# MMF TDECQ / SECQ discrepancies and corner cases

Piers Dawe

Mellanox

*New material about transition time on slides 6 and 7 (D1.1 comments 8 and 9)  
New material about over-emphasis on slides 6 and 8 (D1.1 comments 5 and 6)*

# TDECQ map comparing MMF TDECQ/SECQ with SMF – corner cases

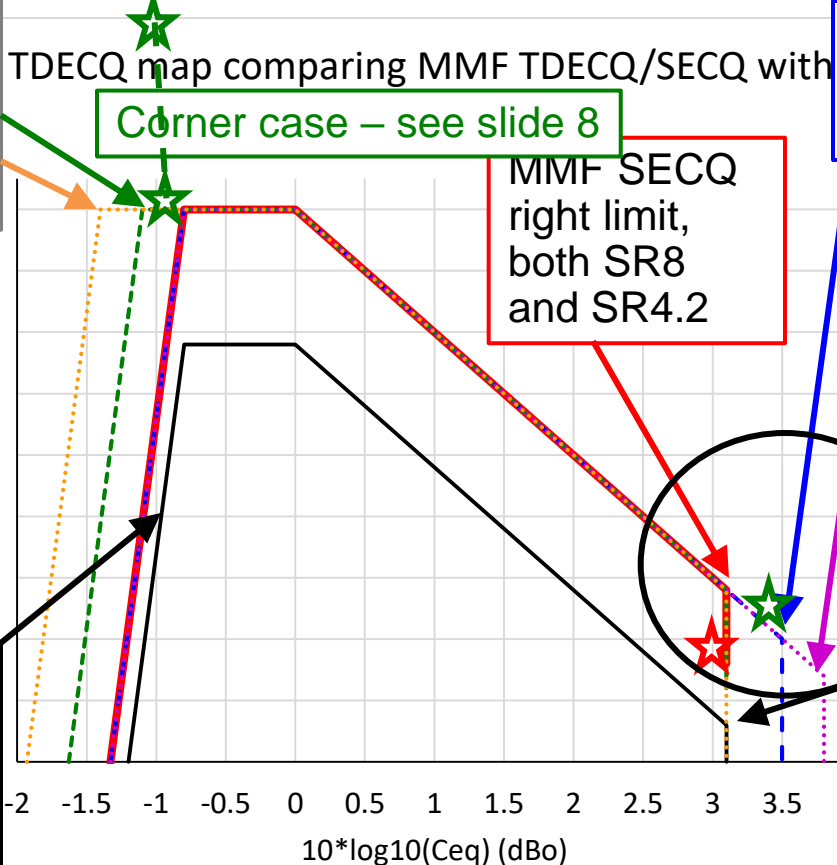
Three stars for clean signals at transition time limit

## TDECQ or SECQ vs. transition time

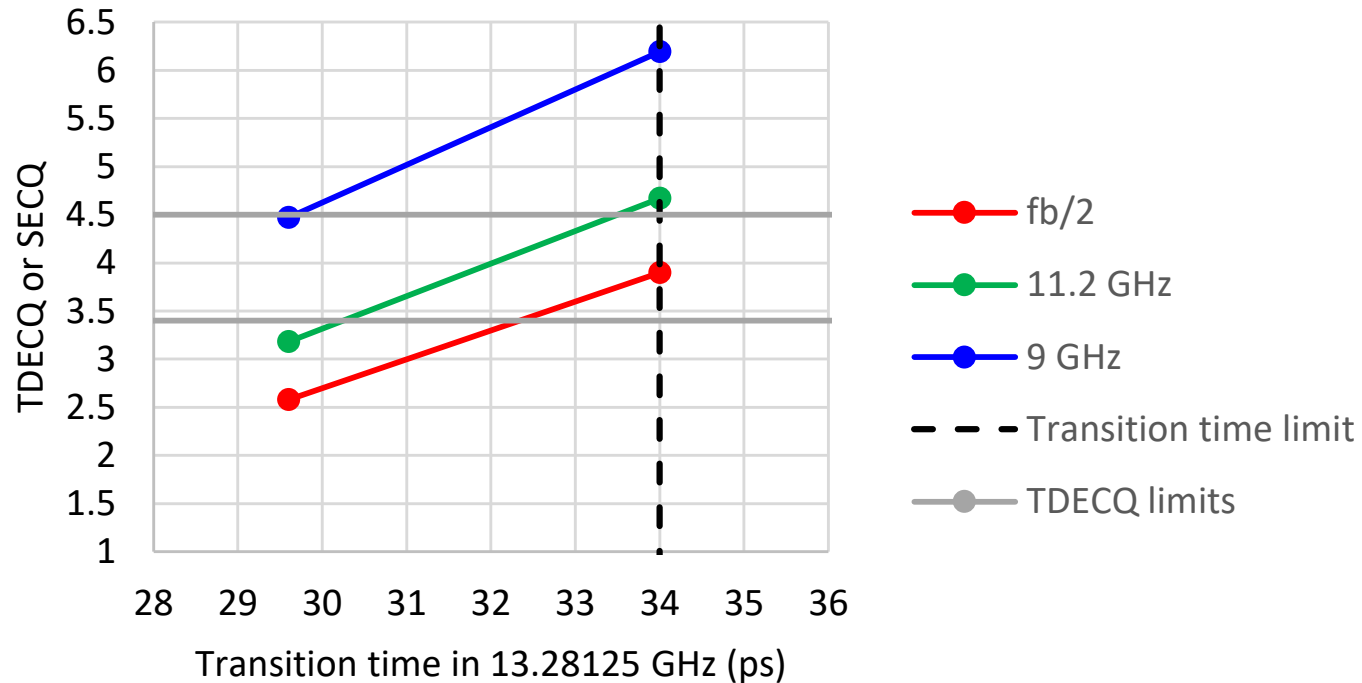
29 to 30 ps for 150 m MMF **Comment 8: This limit should be tightened, or the transition time measured in the same bandwidth as TDECQ**

If the transition times were measured in the same bandwidth as the associated TDECQ, the lines would be close to each other, where the red line is

# Example over-emphasised signal (top left green stars on slide 6)

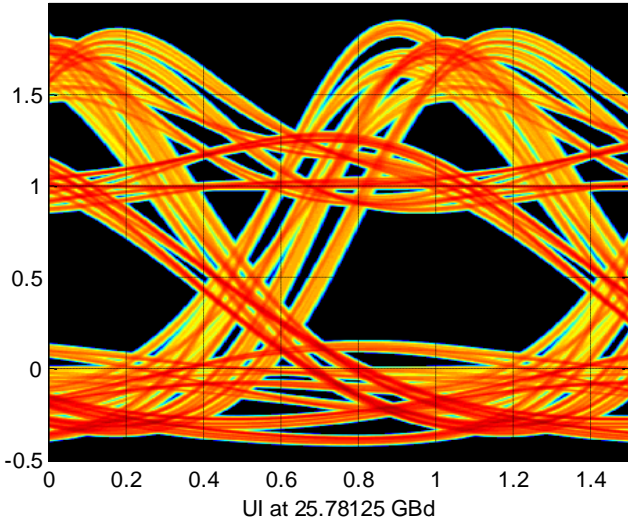
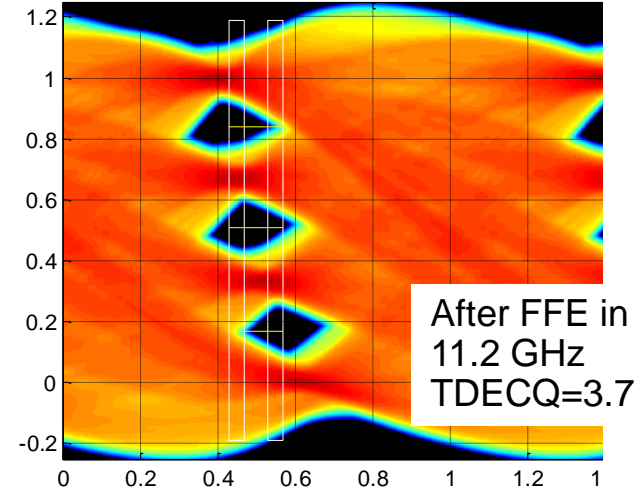
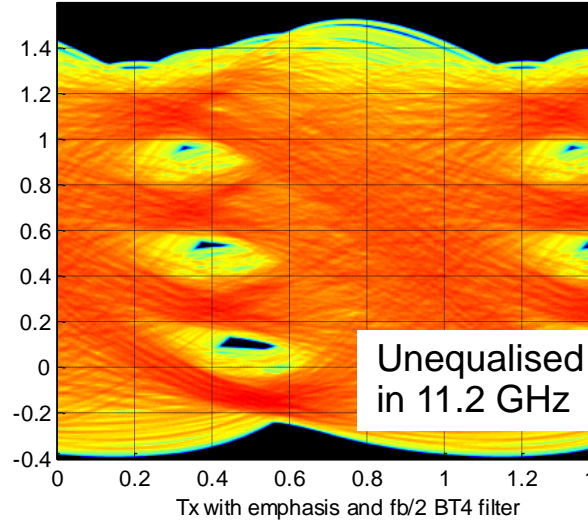
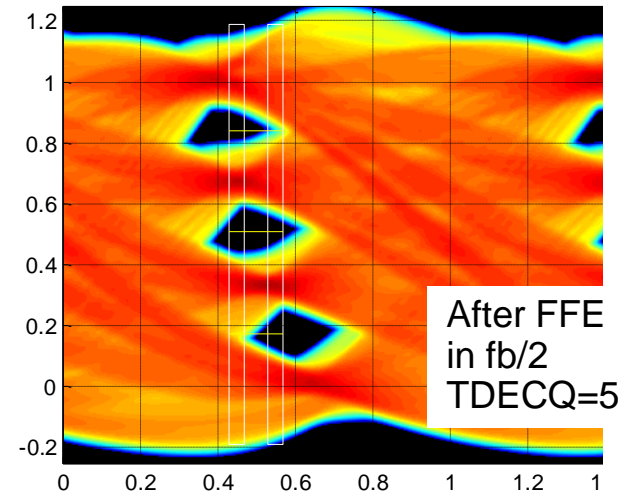
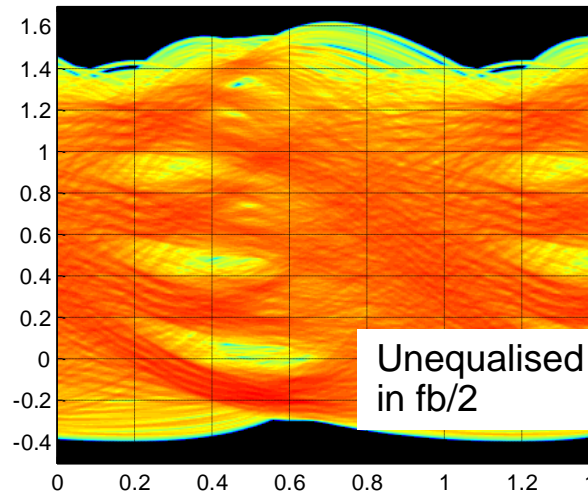
- Top left: transmitter with PAM2 signal
- 0 and 1 are OMA's zeros and threes
- Note different y scales
- This over-emphasised signal benefits from the low bandwidth in MMF TDECQ
- Fails back-to-back

**Should either measure TDECQ in fb/s as well as 11.2 or 9 GHz, or increase minimum cursor tap, or both**
